Proposed Project Modifications

V25 and V26

V33

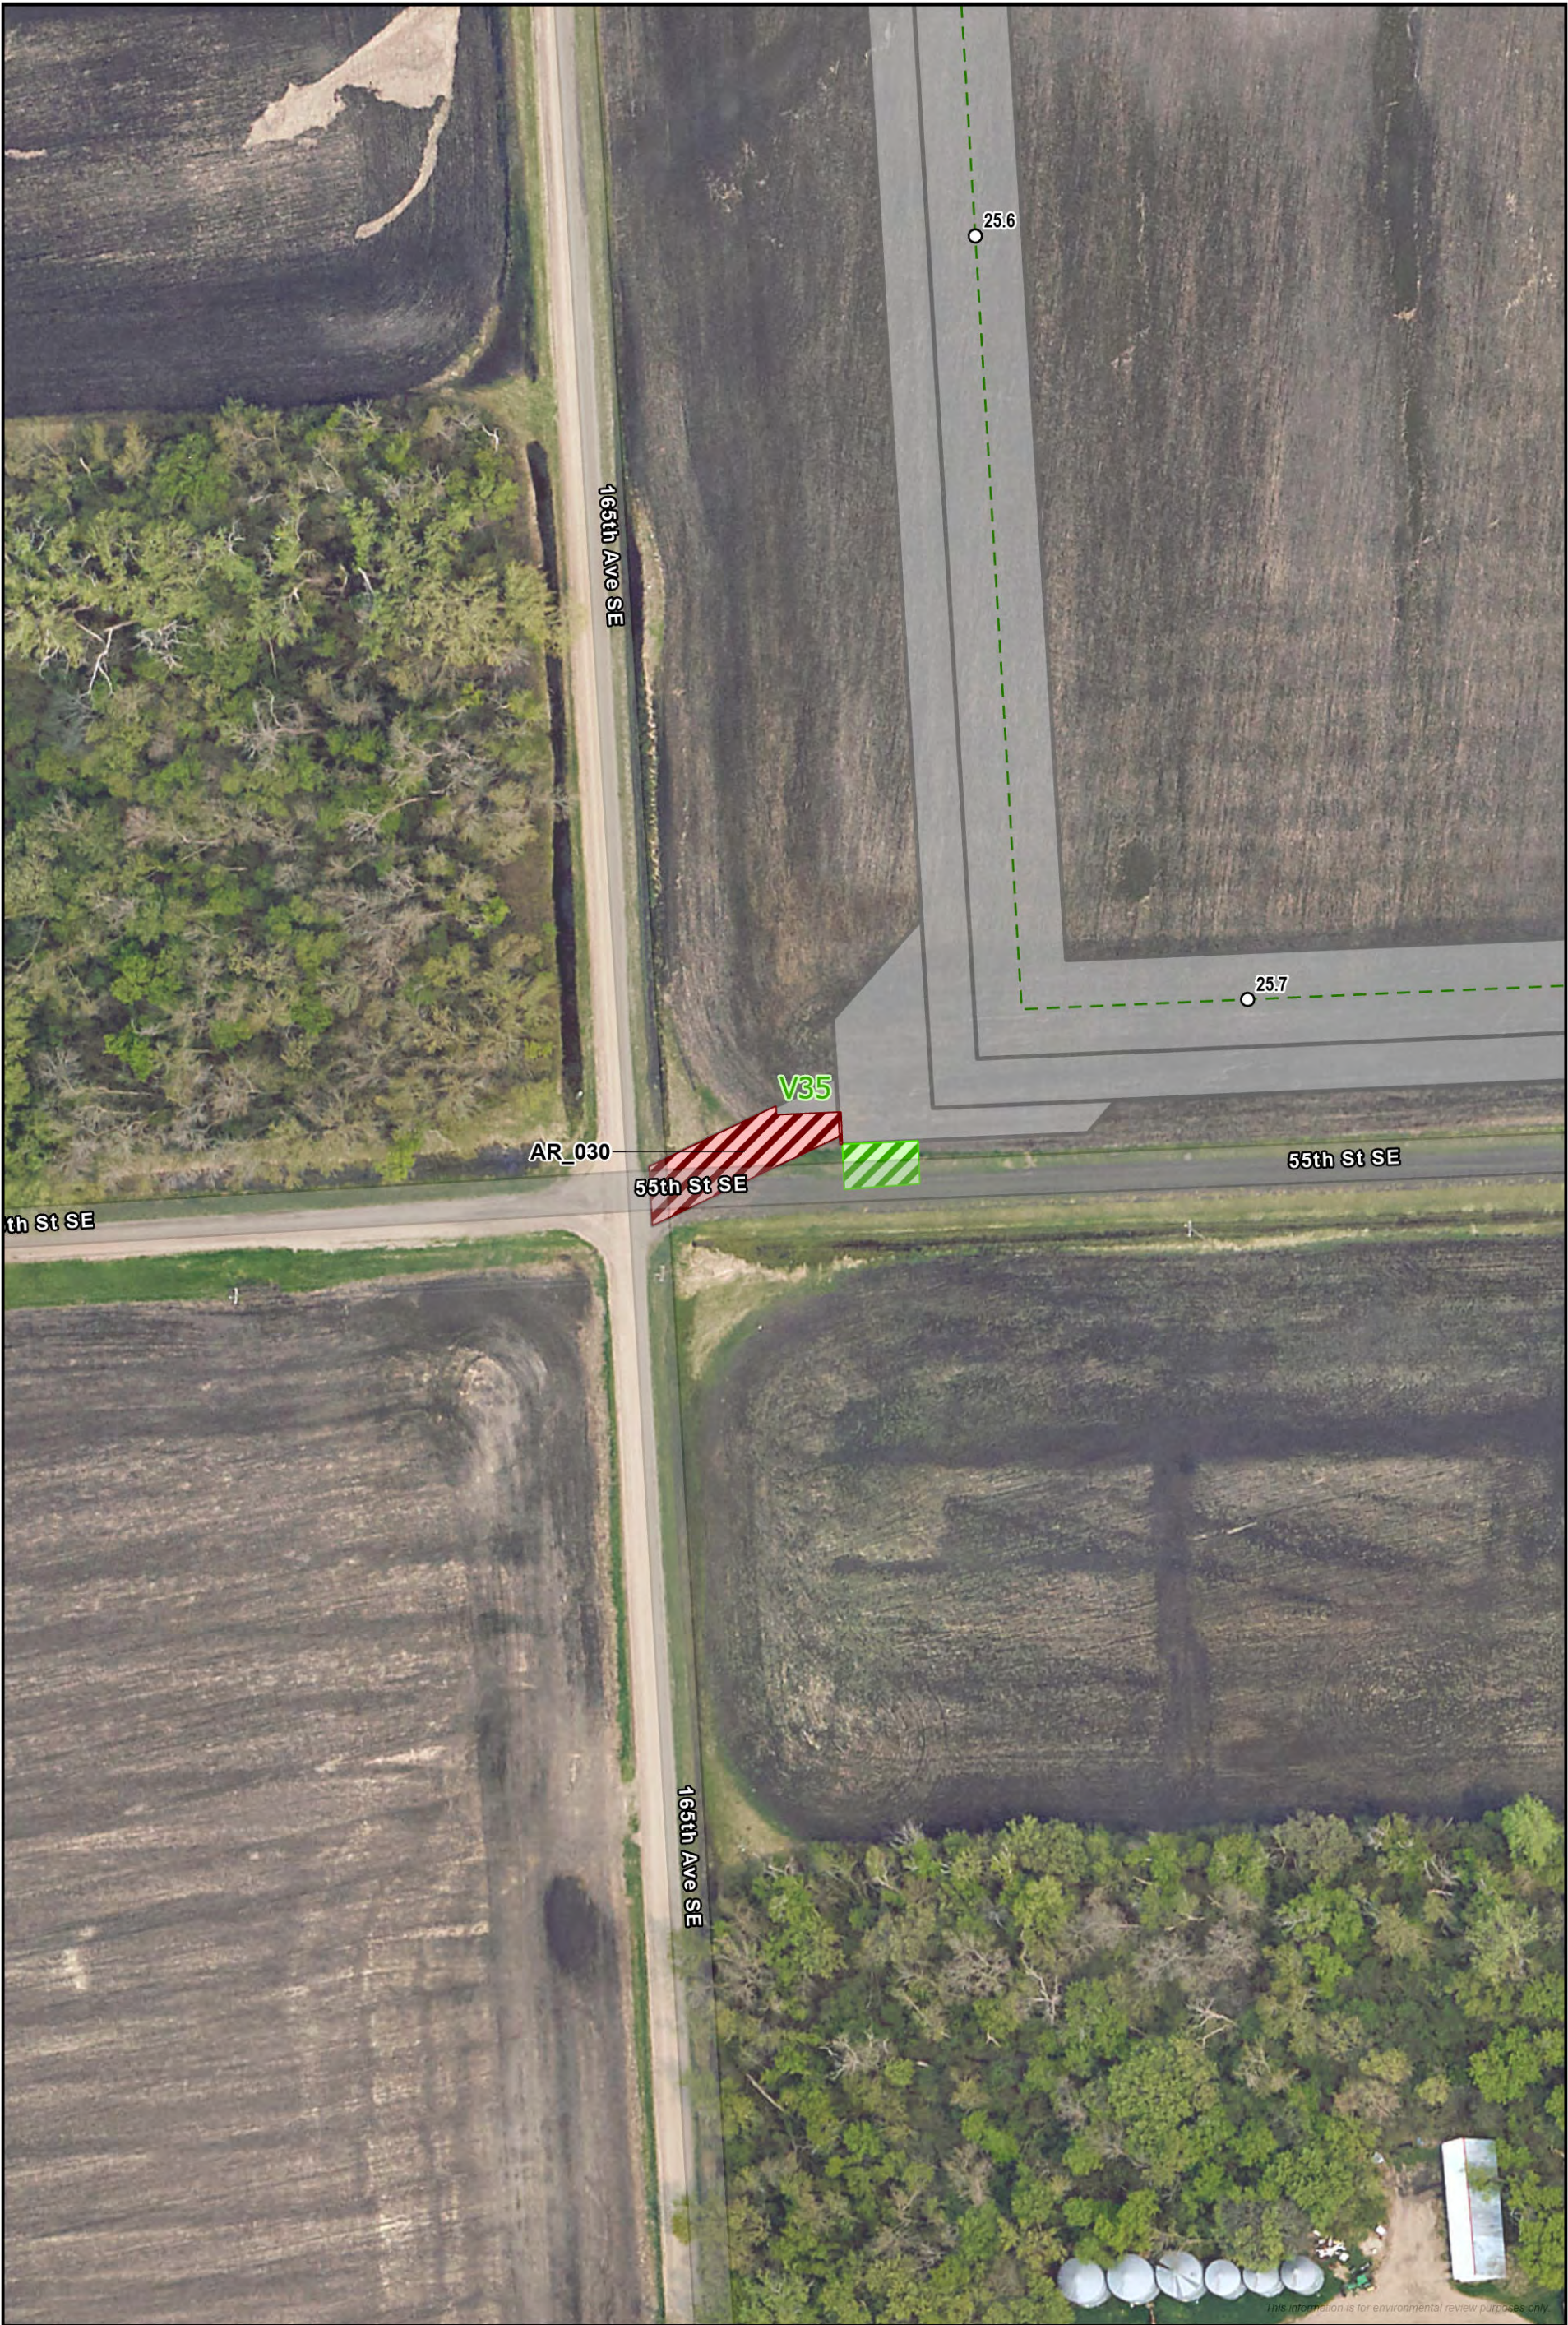
- Milepost
- - - Proposed Centerline
- ▨ TEMP Workspace Added
- No Change
